May 15, 2019
BOARD OF COUNTY COMMISSIONERS
ORANGE COUNTY, FLORIDA

Y19-751-CH/Addendum #4

**CONNECTOR ROAD FROM HILTON DRIVEWAY TO APOPKA VINELAND ROAD
INTERSECTION IMPROVEMENTS**

Bid Opening Date: May 30, 2019

SHEET NO.
65

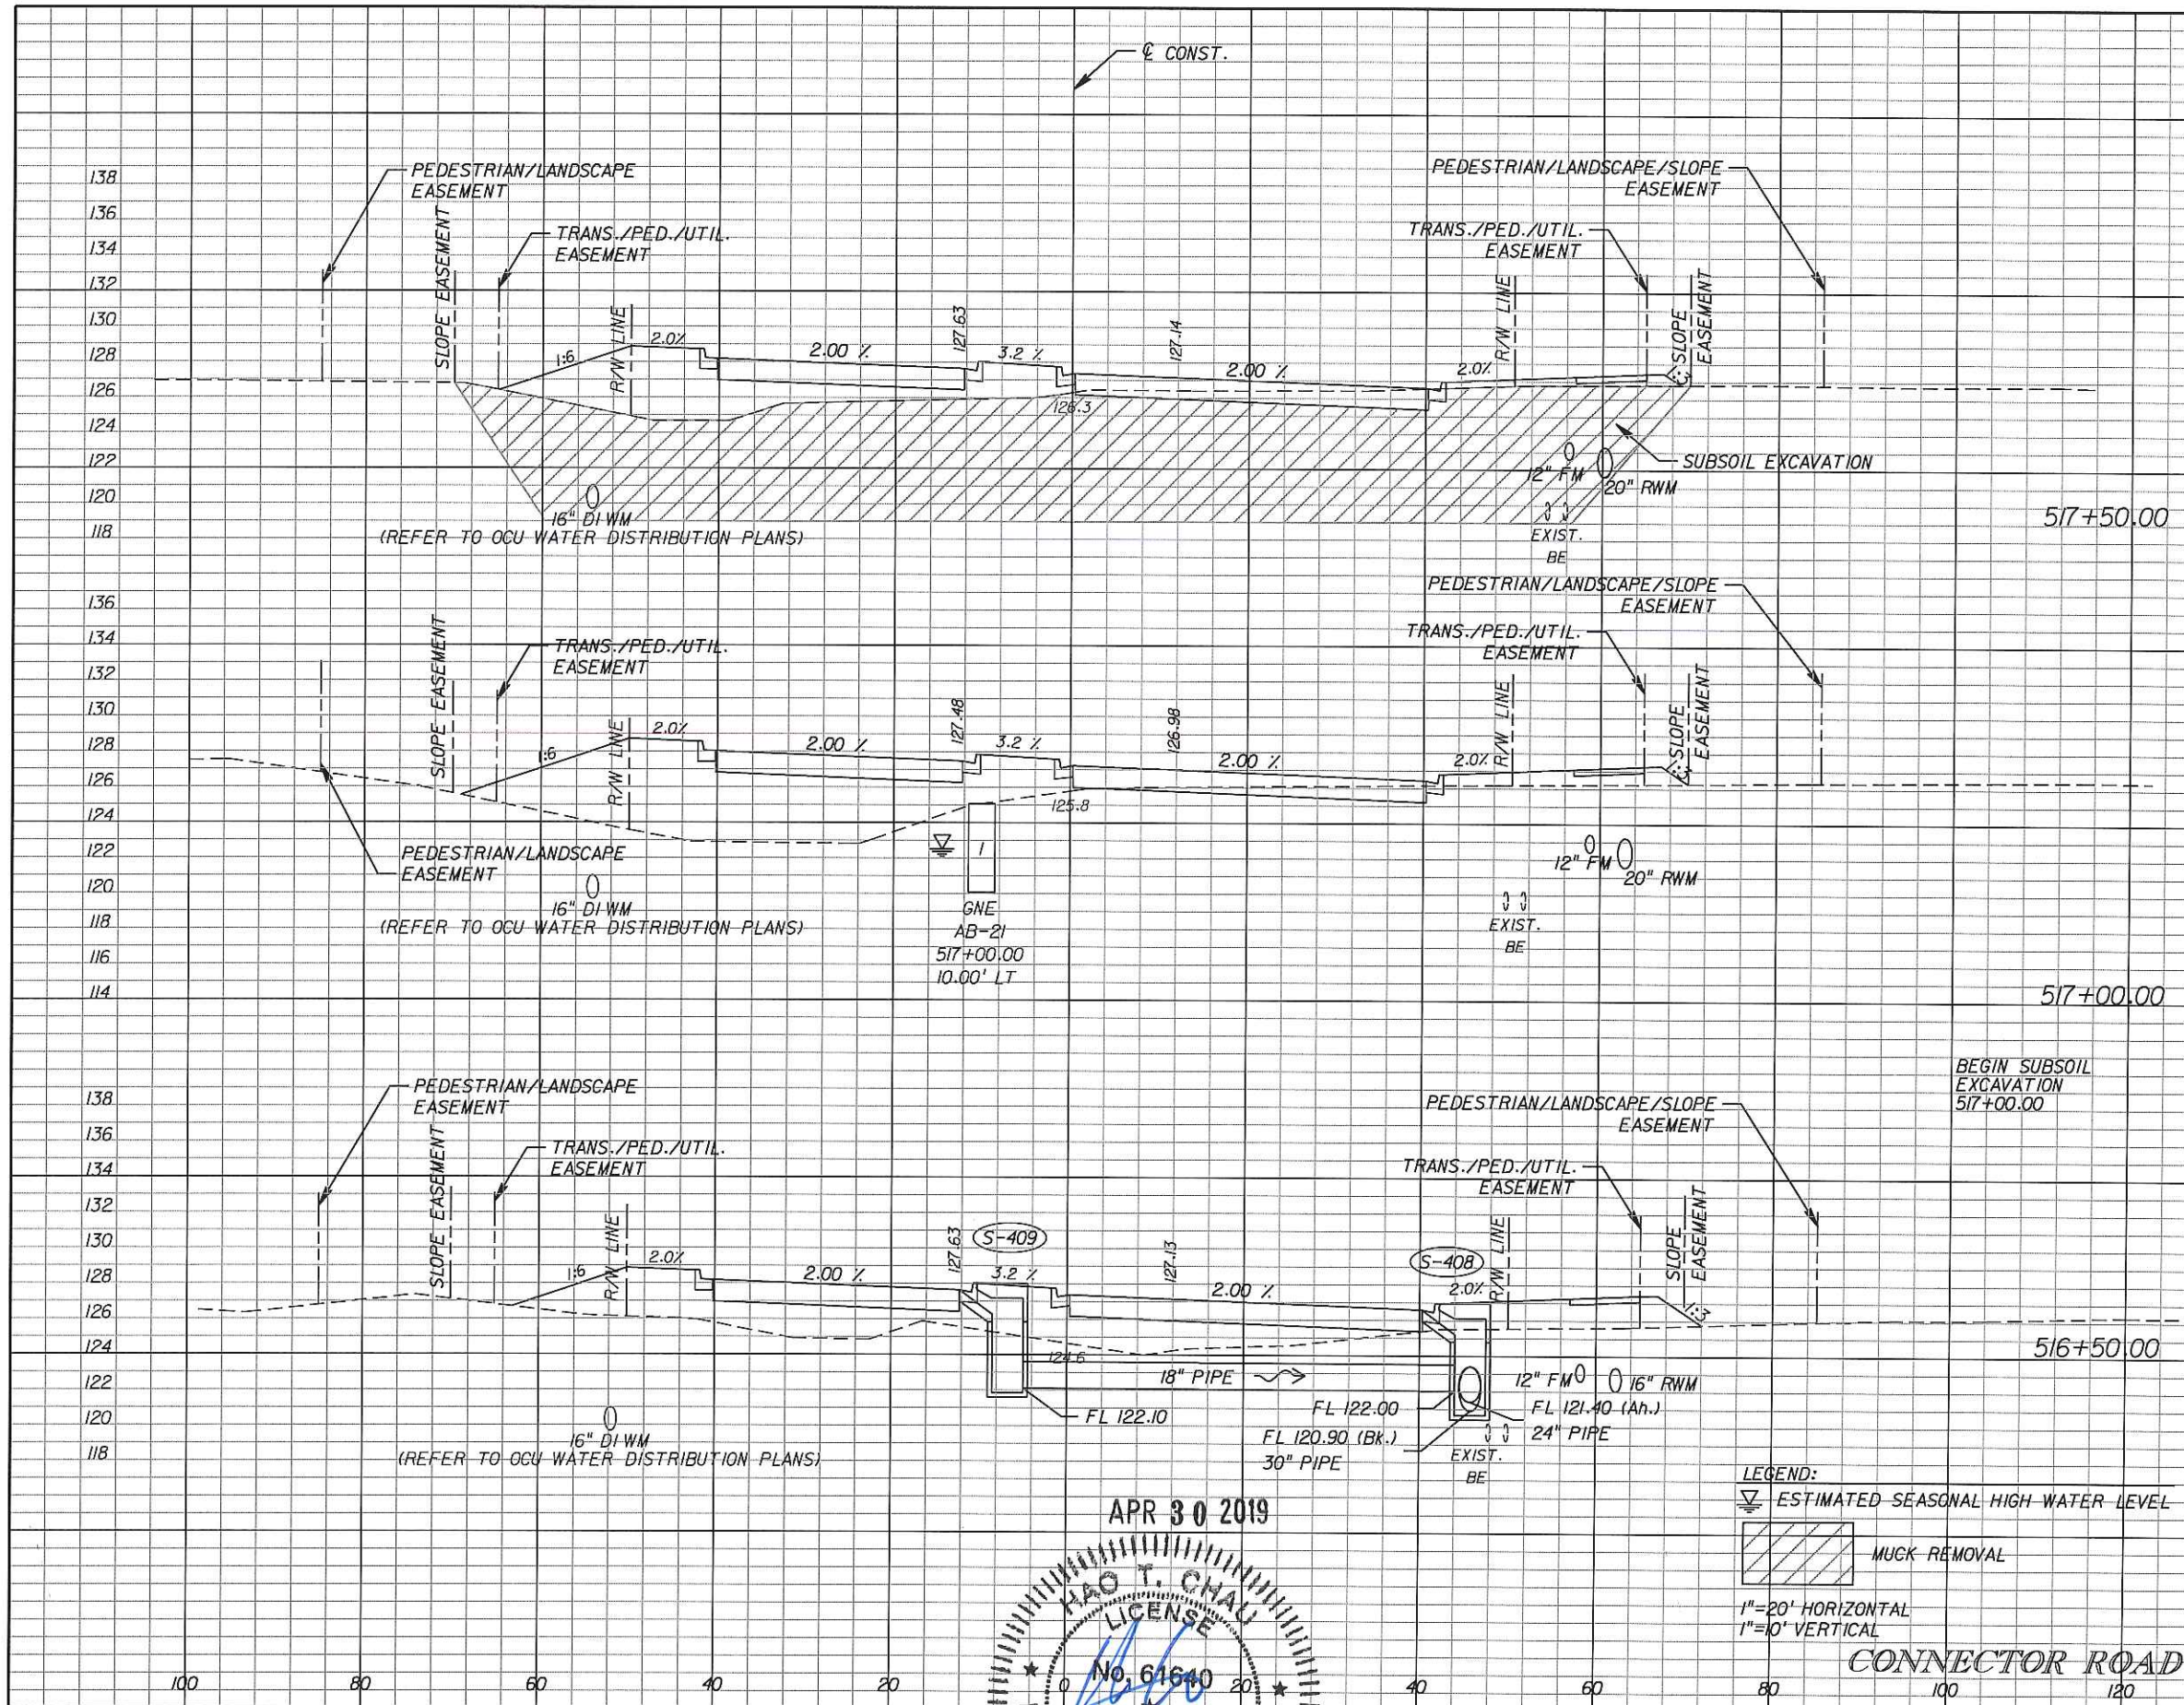
DATE	BY	DESCRIPTION	DATE	BY	DESCRIPTION
04/30/19		1 REVISED EMBANKMENT QUANTITIES

SHEET NO.
 83

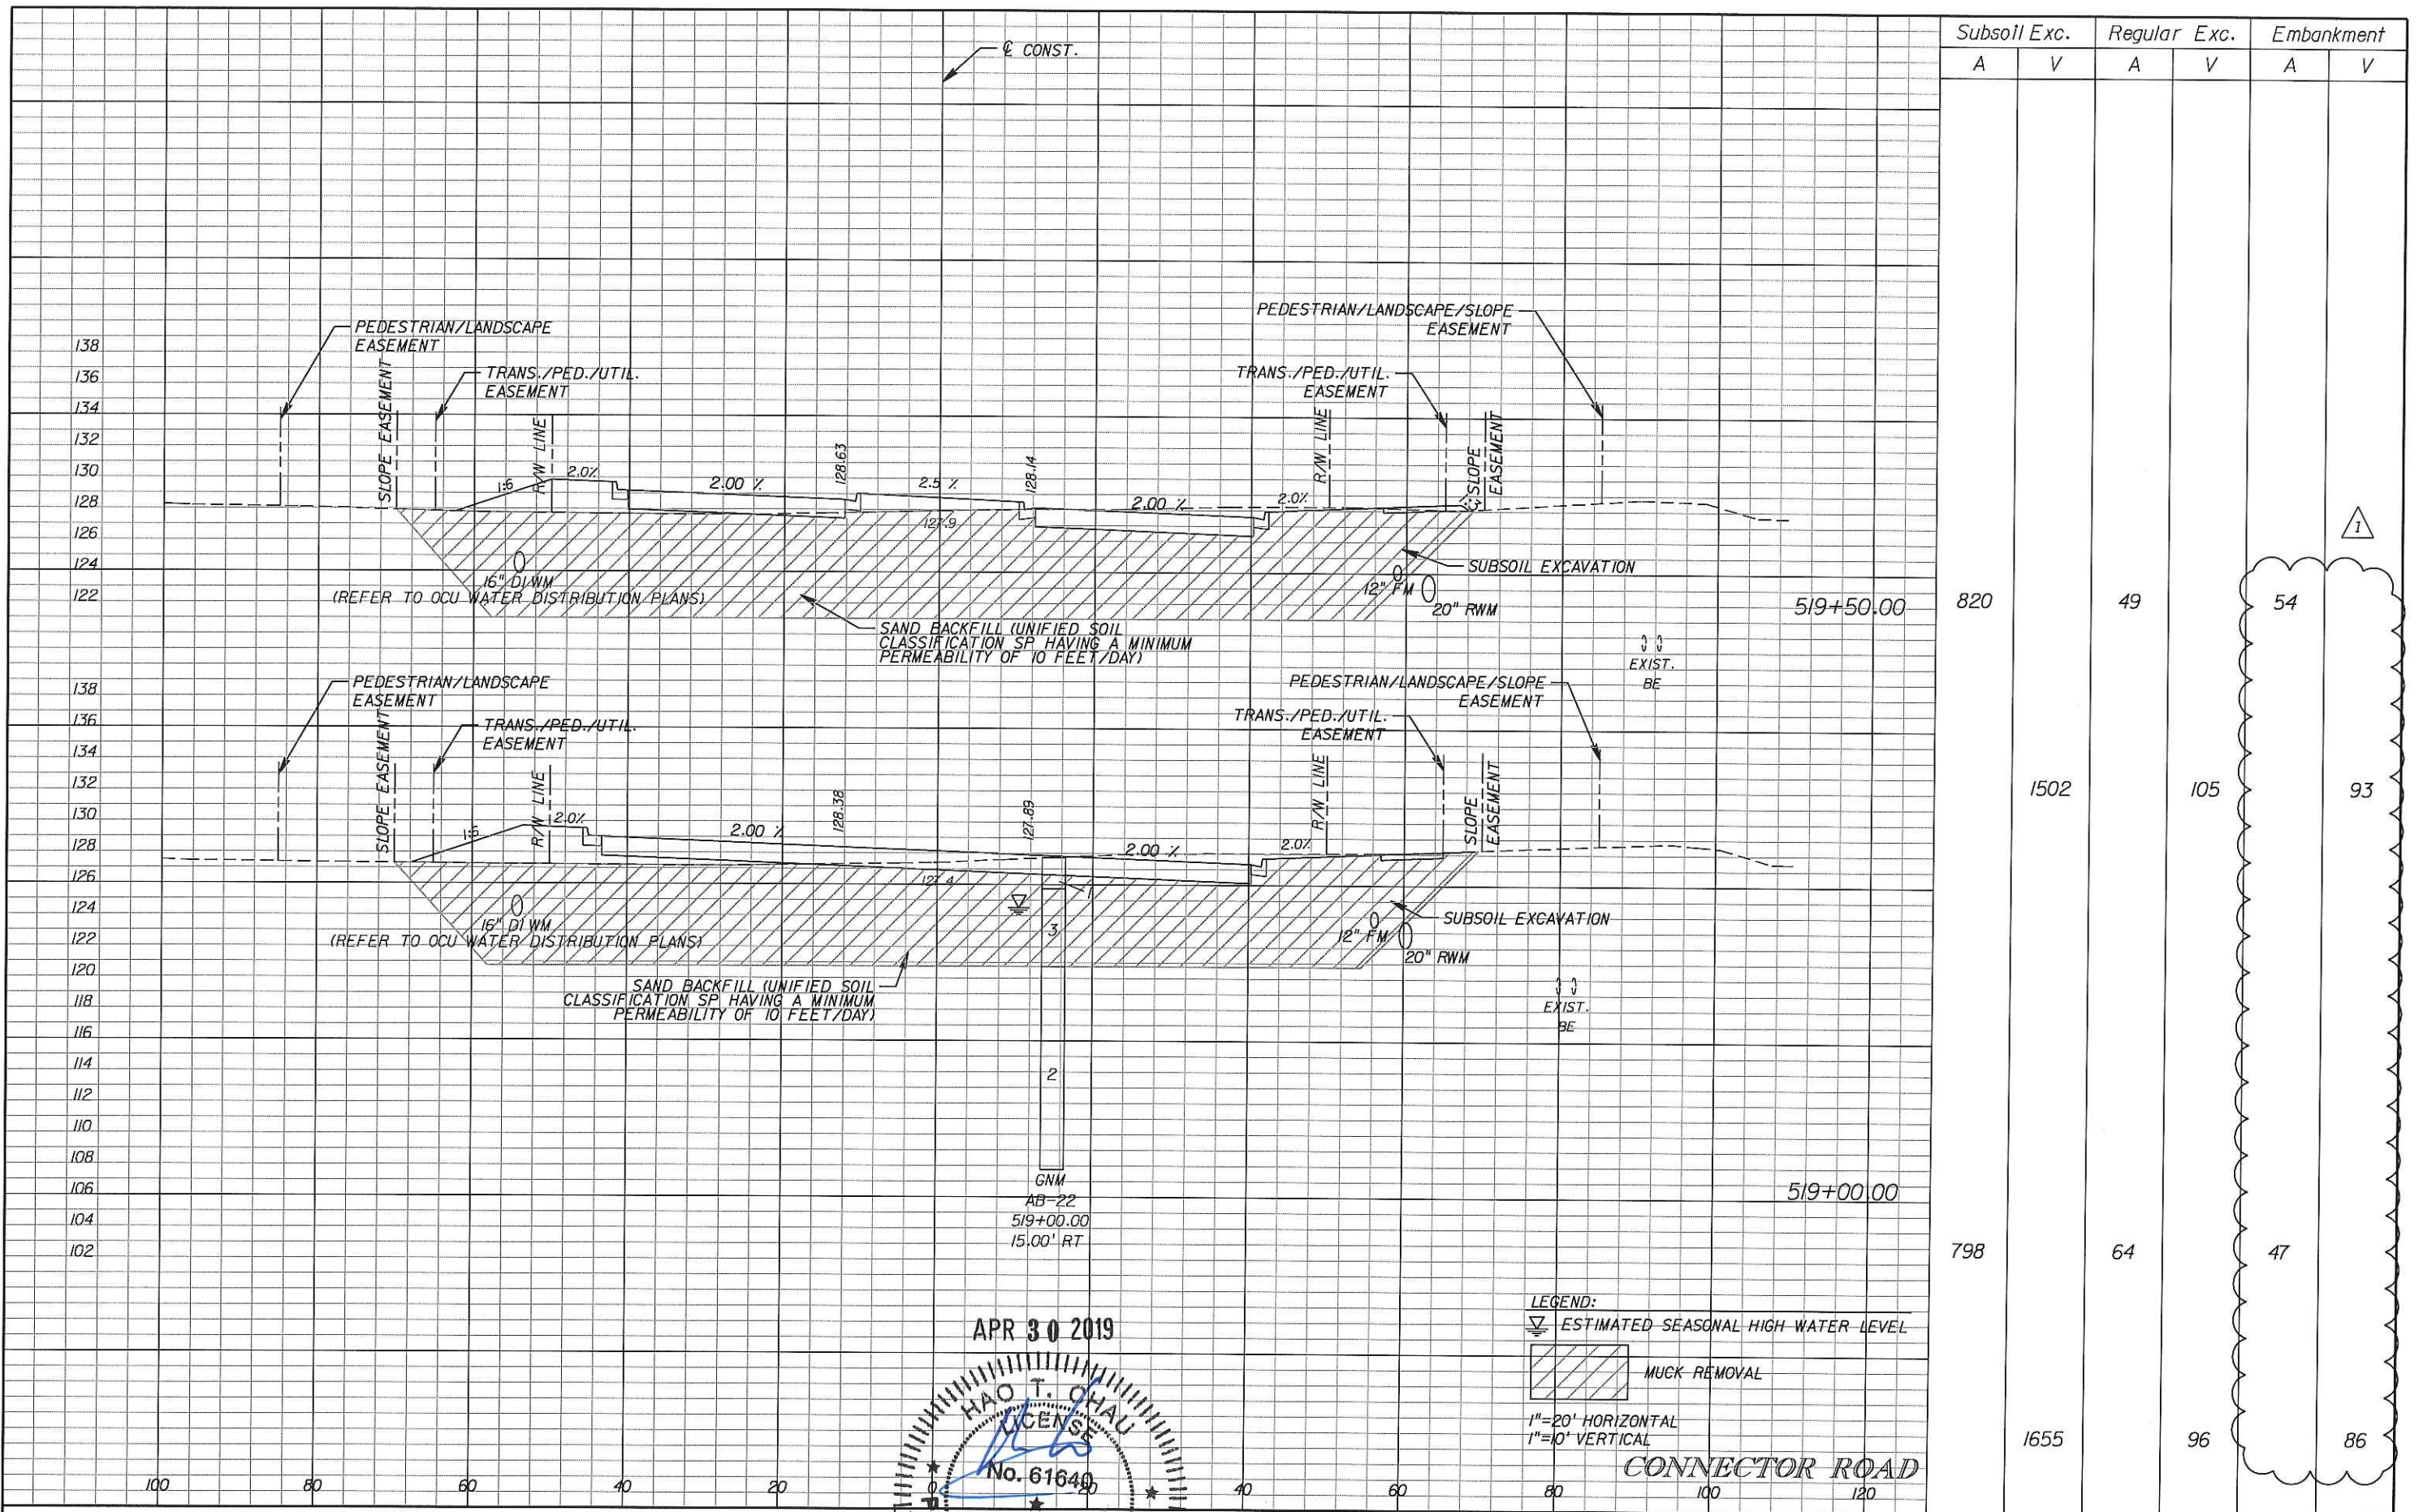
DATE	BY	DESCRIPTION	DATE	BY	DESCRIPTION
04/30/19	1	REVISED EMBANKMENT QUANTITIES

SHEET NO. 85

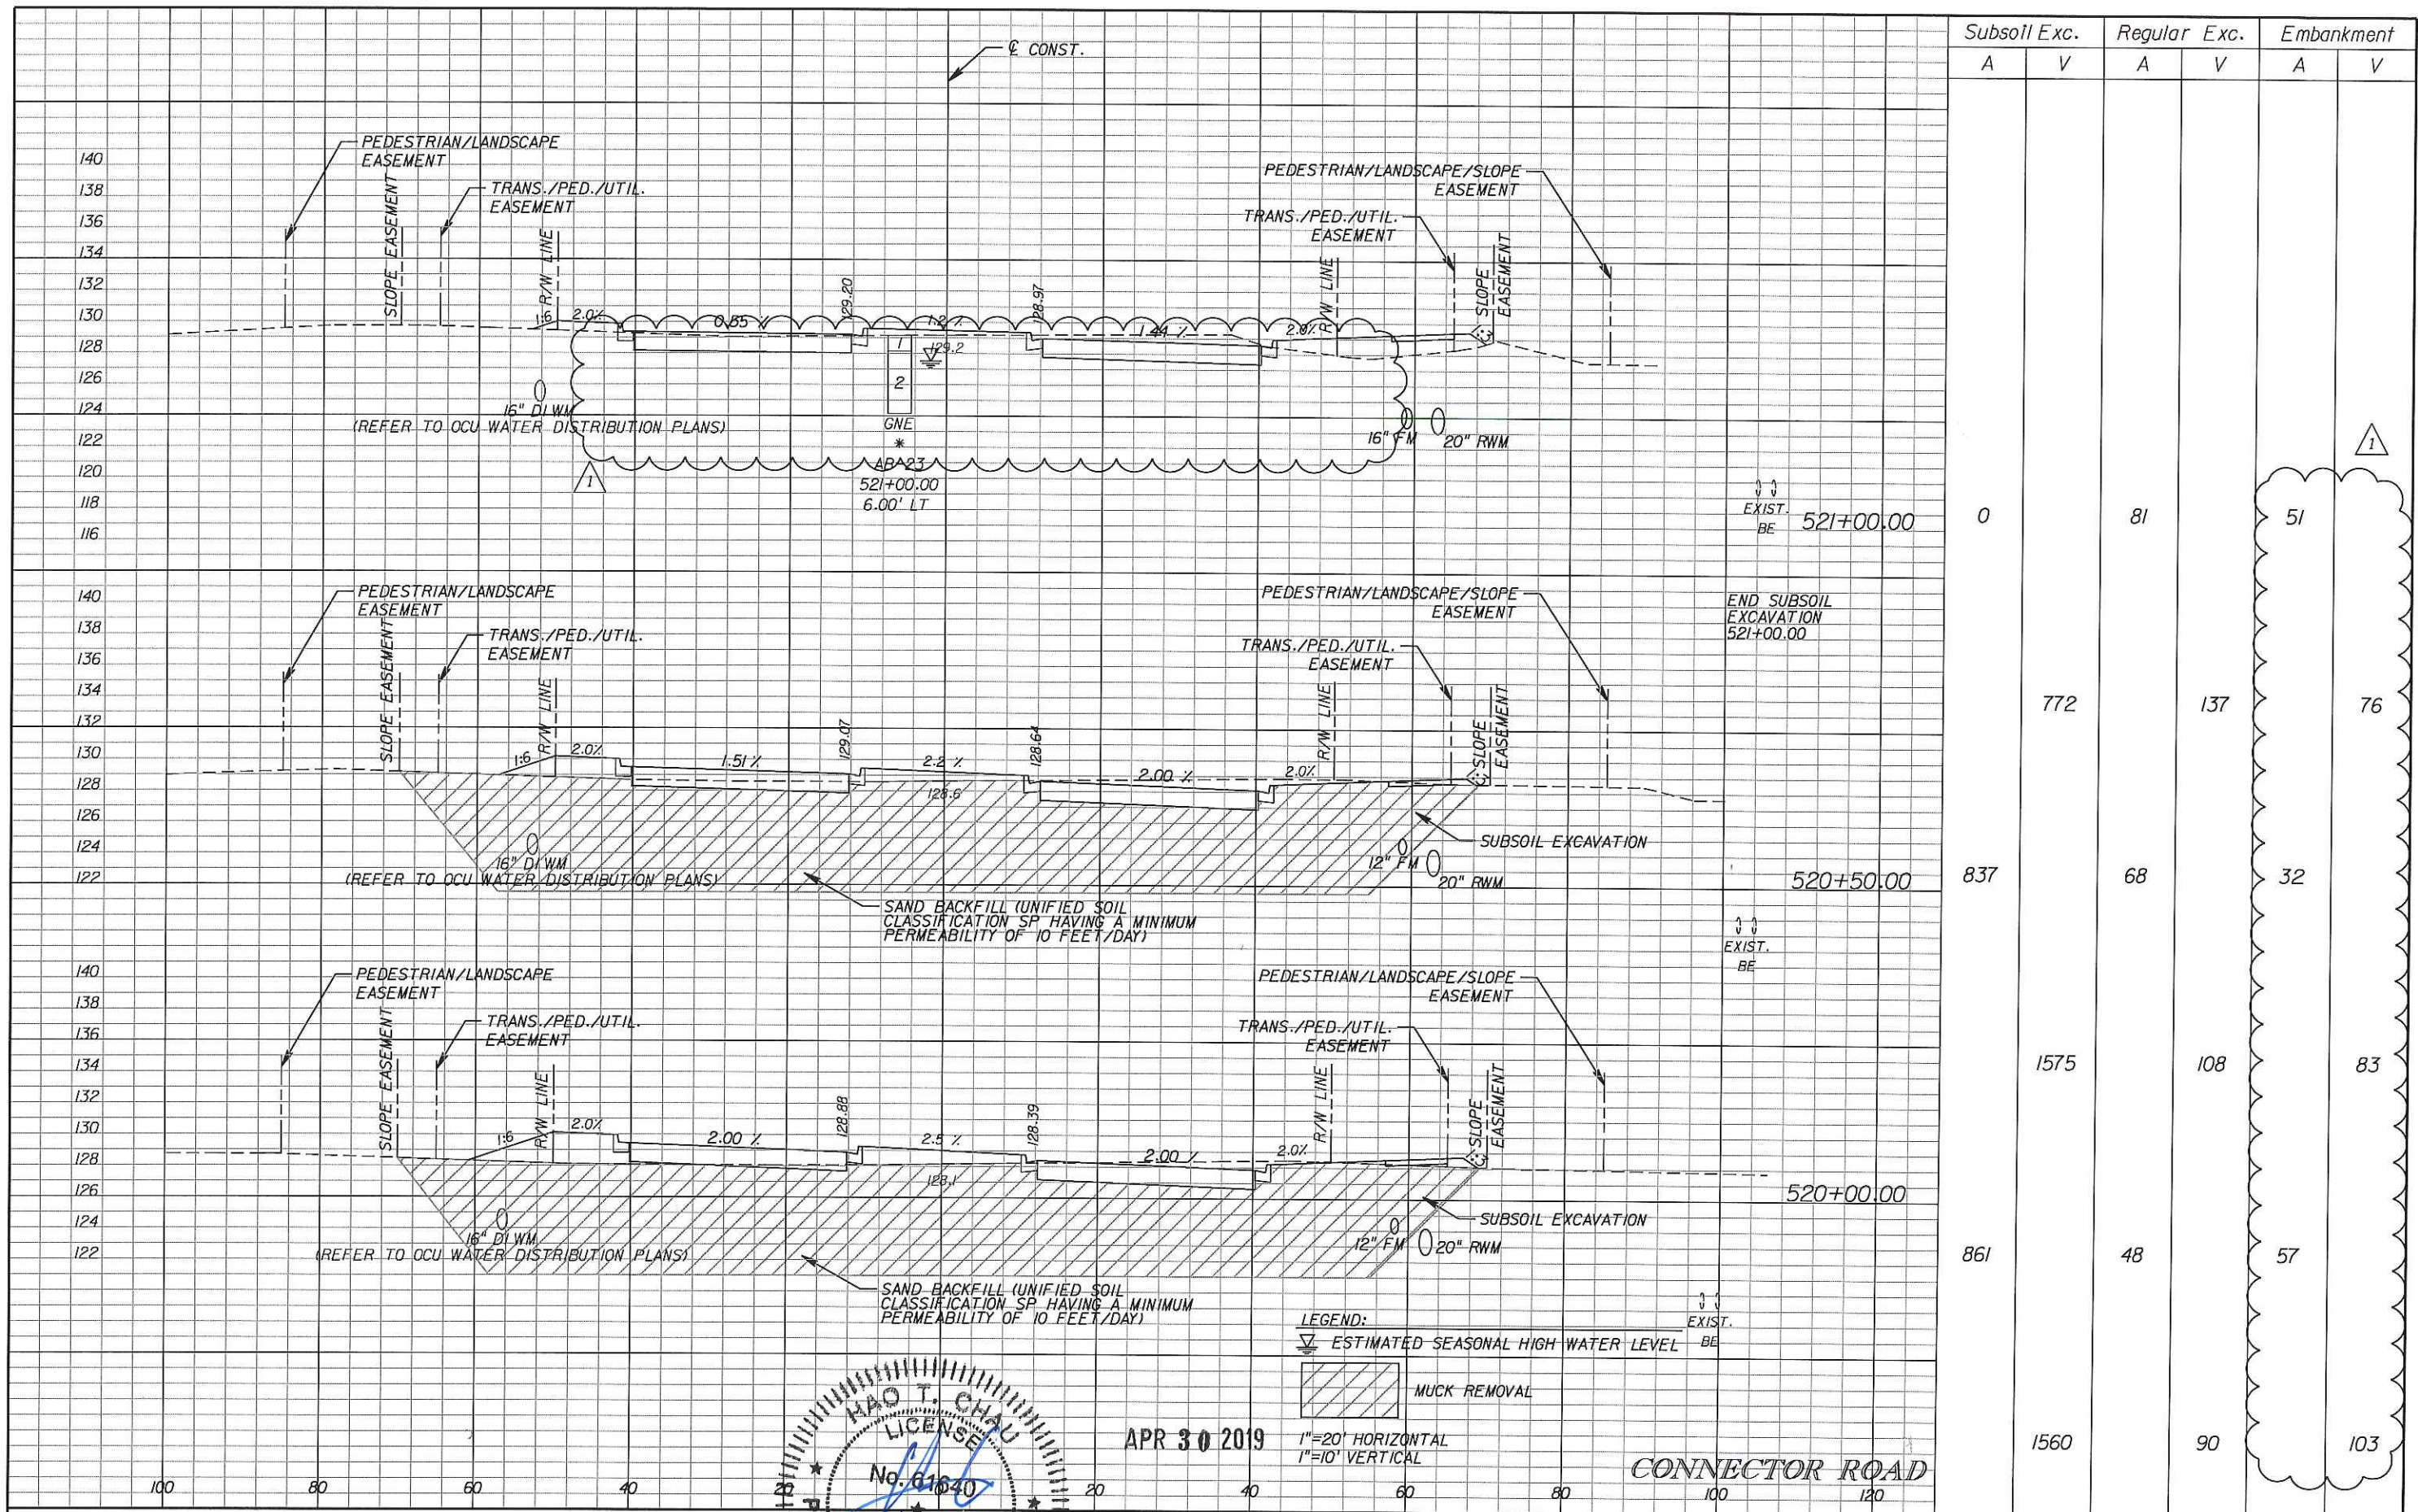
DATE	BY	DESCRIPTION	DATE	BY	DESCRIPTION
04/30/19		1 REVISED EMBANKMENT QUANTITIES
